Beckfoot Upper Heaton School - Accessibility Action Plan.

Updated: 10/01/2025

13.11

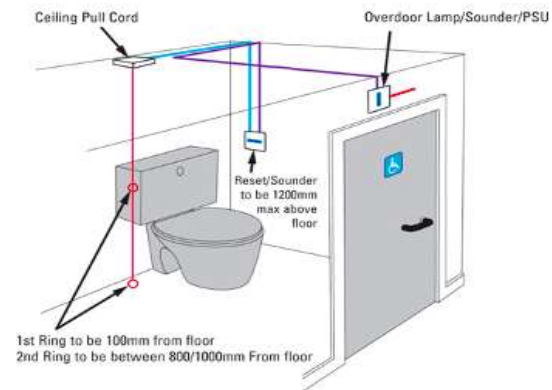
The cord alarm in reception was not freely hanging within a suitable distance of the floor.

The cord alarm on the first-floor facility was marginally high from ground floor level.

The cord alarm in the hygiene room was looped around a grab rail.

The cord alarm in the facility near to the dining area was marginally high from ground floor level.

If cord alarms are not hanging within a suitable distance of the floor, distress calls may go unnoticed.

Implement a management procedure to ensure that cord alarms are always kept loose and not tied up.

According to BS8300 - An emergency assistance pull cord should be sited so that it can be operated from the WC and from an adjacent floor area. The emergency assistance pull cord, coloured red, should be provided with two red bangles of 50 mm diameter, one set at a height between 800 mm and 1000 mm and the other set at 100 mm above floor level.

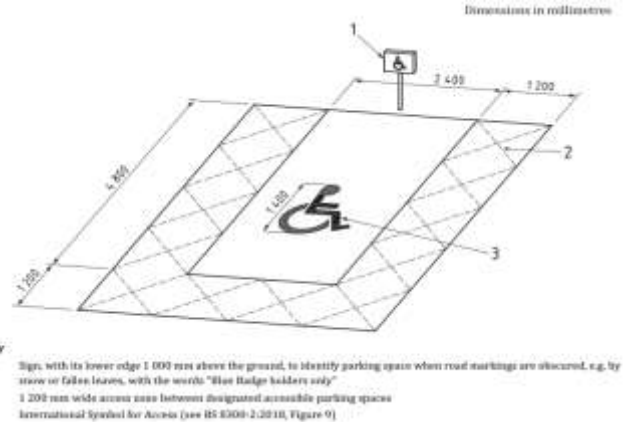
8.6	<p>Most doors, including those to classrooms and offices, featured suitable opening pressure.</p> <p>The double door systems, leading from their stairwells on each floor required slightly heavy opening pressure.</p> <p>The door leading towards outside, next to the canteen, also featured slightly heavy opening pressure.</p> <p>Heavy pressure doors can be unsuitable for wheelchair users and people with reduced mobility, as they can be knocked off balance.</p>	<p>Implement maintenance to de-tense and recalibrate the hinges. Ensure doors can be opened with less than 30 Newtons of force.</p> <p>If the force required for opening doors is greater than wheelchair users and people with limited strength can manage, they will be unable to continue their journeys independently. If the force of the closing device is too great or its speed too fast, disabled people risk being pushed off balance.</p>	M/N

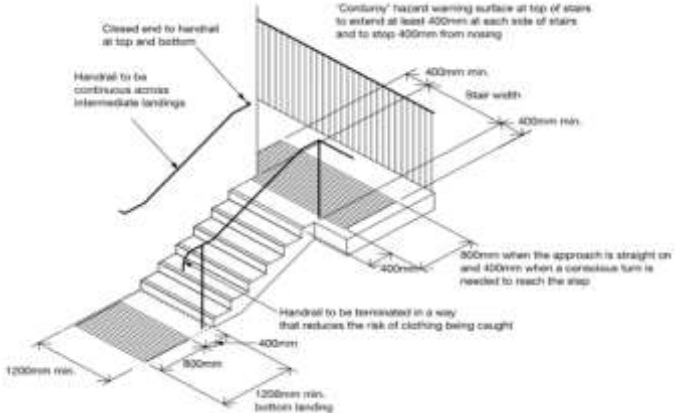
<p>12.4</p>	<p>The compartment doors for the student WC facilities were not well contrasted against the frames.</p>	<p>Cubicle doors throughout should appropriately colour contrasted to identify doors within frames to aid people with impaired vision. A difference of 30 points LRV (Light Reflectance Value) is recommended as appropriate contrast.</p> 	<p>M</p>

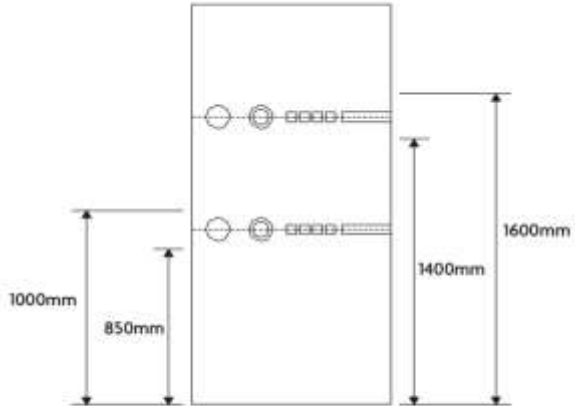
15.5	<p>The location of the lift was not clear on approach to assist with way finding.</p>	<p>The appropriate lift signage should be provided.</p> <p>BS8300 - Signs and universally accepted symbols or pictograms, indicating lifts, stairs, circulation routes and other parts of the building should be provided. Visual signs should be self- evident and, in particular, legible to visually impaired people. Plain English and pictograms together should be used to assist people with learning difficulties.</p>	M
